UNITED STATES PATENT AND TRADEMARK OFFICE

APPLICATION NO.	FILING DATE	FIRST NAMED INVENTOR	ATTORNEY DOCKET NO.	CONFIRMATION NO.
09/737,279	12/14/2000	Seiji Hiroshima	MITS:024	7933

<b>Office Action Summary</b>	Application No.	Applicant(s)
	09/737,279	HIROSHIMA ET AL.
	Examiner Melody M. Burch	Art Unit 3613

## **DETAILED ACTION**

**Fig. 1**

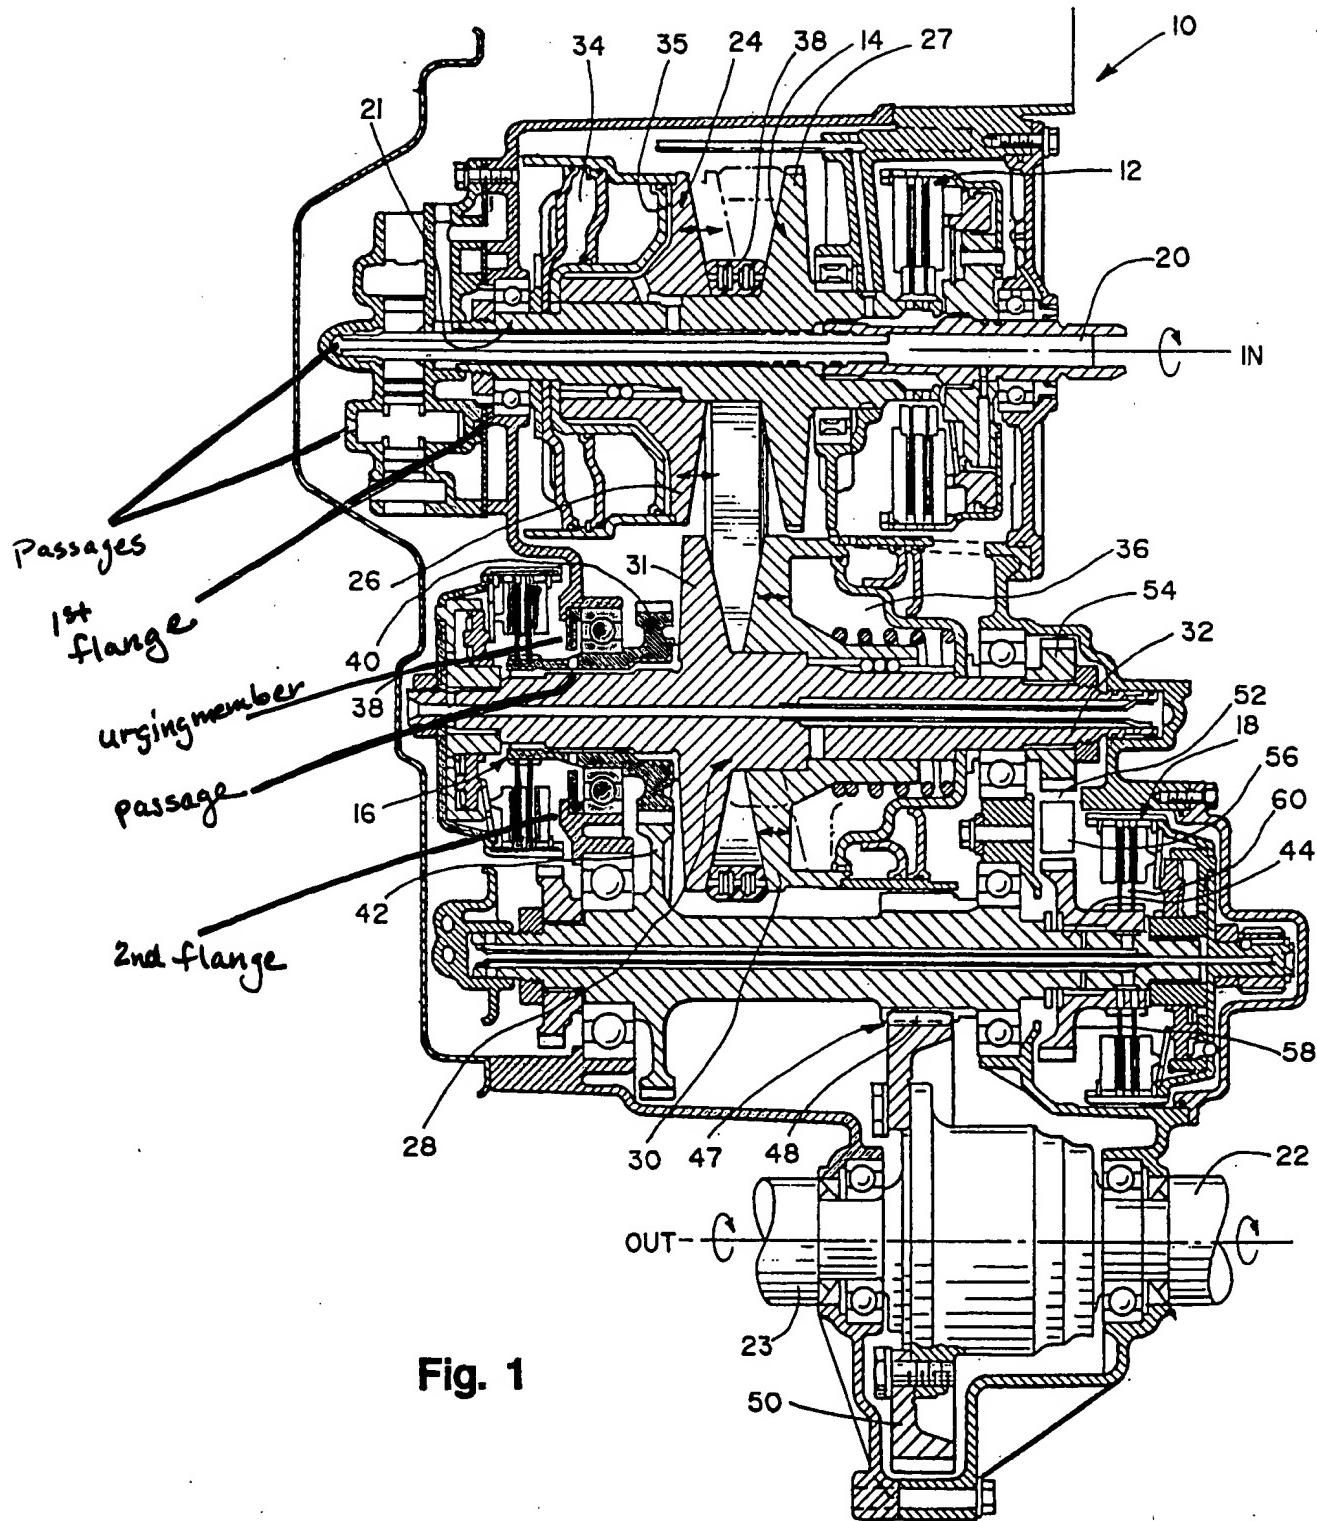
9. Claim 1 is rejected under 35 U.S.C. 102(b) as being anticipated by Neuman et al. Neuman et al. shows in figures 1 and 2 a belt-type continuously variable transmission comprising: a continuously variable transmission mechanism comprising: a primary shaft 20 having a primary pulley 24; a secondary shaft 32 having a secondary pulley 28, and an endless belt 33 wound on the primary pulley and the secondary pulley, a

housing (outlined in blue in the copy of figure 1 attached with the Action) that accommodates the continuously variable transmission mechanism, the housing having an end wall that is formed with a first bearing mounting hole through which one end portion of one 20 of the primary shaft and the secondary shaft penetrates, a first bearing (outlined in yellow in the copy of figure 1 attached with the Action) that is fitted in the first bearing mounting hole and allows the one shaft 20 to be supported rotatably by the end wall, a flange (indicated by the Examiner in the copy of figure 1) that projects from an inside circumferential surface of the first bearing mounting hole on the housing inward side, a bearing retainer (outlined in orange in the copy of figure 1 attached with the Action) that is provided on an outside surface of the end wall so as to project inward in a radial direction of the first bearing mounting hole and that cooperates with the flange to pinch the first bearing, and a first cover (outlined in yellow in the copy of figure 1 attached with the Action) that is connected to the housing (at the bottom of the figure) and covers the one end portion of the one shaft and the bearing retainer.

11. Claims 2-8, 10, and 11 are rejected under 35 U.S.C. 103(a) as being unpatentable over Neuman et al. in view of Lamers. Neuman et al. show in figures 1 and 2 the end wall being formed with a second bearing mounting hole shown to the left

of element number 31 through which one end portion of the other 32 of the primary shaft and the secondary shaft penetrates, the belt-type continuously variable transmission further comprising: a second bearing (outlined in orange in the copy of figure 1 attached with the Action) that is fitted in the second bearing mounting hole and allows the other shaft 32 to be supported rotatably by the end wall, an urging member (outlined in red in the copy of figure 1 attached with the Action) that is in contact with a side surface of the second bearing on the housing inward side, and a second cover (outlined in red in the copy of figure 1 attached with the Action) that is connected to the housing via element 32 and the second bearing and covers the one end portion of the other shaft 32 and cooperates with the urging member to pinch the second bearing in the axial direction .

12. Claim 9 is rejected under 35 U.S.C. 103(a) as being unpatentable over Neuman et al. in view of Lamers as applied to claim 2 above, and further in view of Hattori. Neuman et al. show in figure 1 the first and second covers having passages as indicated by Examiner in the copy of figure 1 attached to the Action. Hattori teaches the
